Information note

N° 021/22

Change of the 2-character (“YW”) Date Code on Package Marking for International Rectifier (IR) Legacy Packages

Customer Information Package
Information Note: 021/22

2-character ("YW") Date Code Package Marking (Examples SOT23-3)

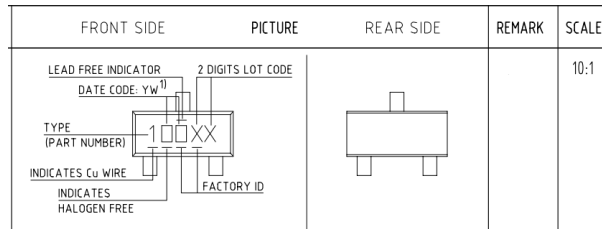
Y2025 W31 = 'EE'

**IR Format
(Existing)**

Y2025 W31 = '5e'

**IFX Format
(To-Be)**
